## Noise During Start Up – Install Revised Timing Chain Tensioners

**MODEL**1997-99 MY XK8 Range  
1998-99 MY V8 XJ Series**VIN**Refer to engine  
no. in text**Issue:**

ILLUSTRATION 1

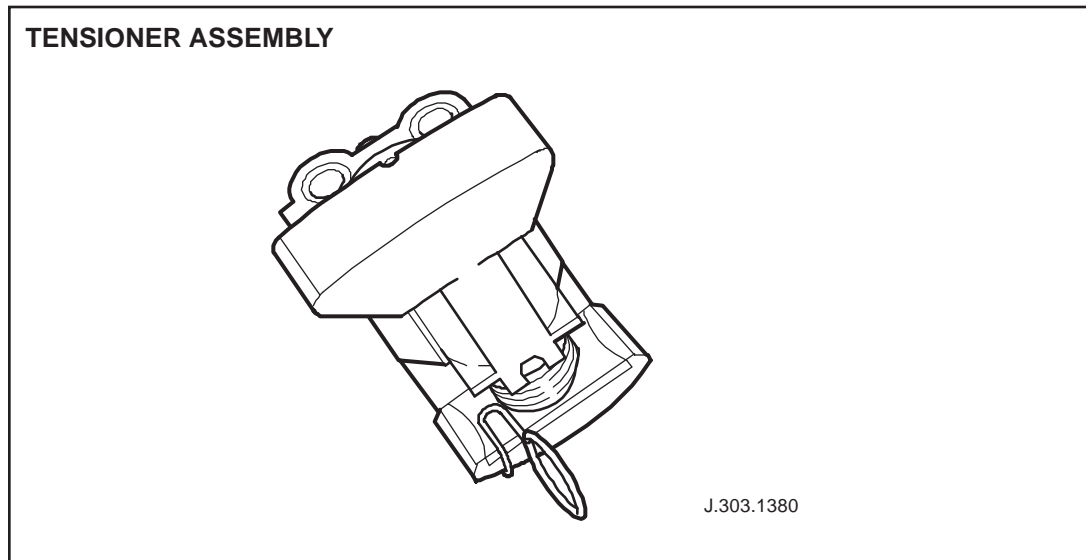
A revised, spring assisted, secondary timing chain tensioner has been introduced to eliminate this concern, commencing at engine No. 98102106XX. Introductory VINs are not yet available. In case of a customer complaint, the revised tensioners may be installed on earlier V8 engines.

In case of a customer complaint of start up noise, determine if the noise is caused by the secondary timing chain tensioners. If the secondary timing chain tensioners are the cause of the noise, they should be replaced by the revised tensioners (Illustration 1).

- The revised tensioner has a coil spring that presses on the piston head to provide a damping effect.
- To simplify the installation of the tensioner on the engine, a clip (shown in Illustration 2) is provided to hold the piston in a partly compressed position during assembly.

ILLUSTRATION 2

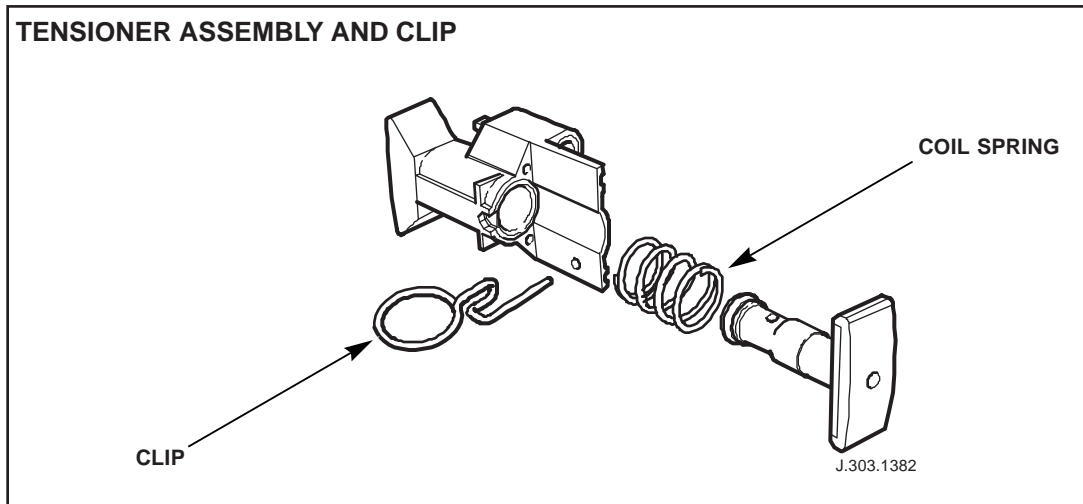
- When the piston and spring assembly is compressed to approximately half of its travel, the pin end of the clip is inserted into the hole in the tensioner body, in front of the piston head/slipper, with the finger ring of the clip positioned at the rear of the head, (as shown in Illustration 1).
- Installation of the tensioners is covered in JTIS 5, section 303-01, Basic Engine, Removal and Installation, Timing Chain Tensioner (Secondary) - A-Bank (12.65.63) or Timing Chain Tensioner (Secondary) - B-Bank (12.65.64).
- The method of removing and reinstalling the secondary timing chain tensioners has been simplified by the use of a ball-end drive bit as described in Technical Bulletin 303-28, dated 8/98.

ILLUSTRATION 3

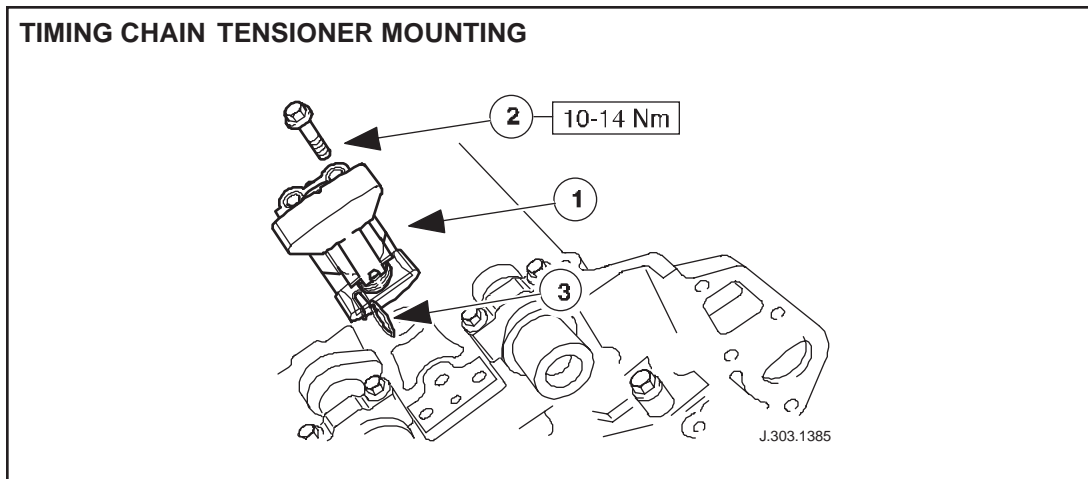
- The installation of the revised tensioner, (1, Illustration 3), is the same as the original style tensioner except that it must be installed in the compressed condition (retained by the clip).
- The retaining bolts should be tightened to the recommended torque setting of 10-14 Nm (7.4-10.3 lb. ft, 88.5-123.9 lb. in.), (2, Illustration 3), before the clip (3, Illustration 3), is removed to release the piston and tension the secondary chain.

**Note:** After installing a revised tensioner and removing the clip, save the clip as a service tool to assist in any future removal and reinstallation. To avoid the loss of the clip inside the timing cover, attach a length of string to assist retrieval.
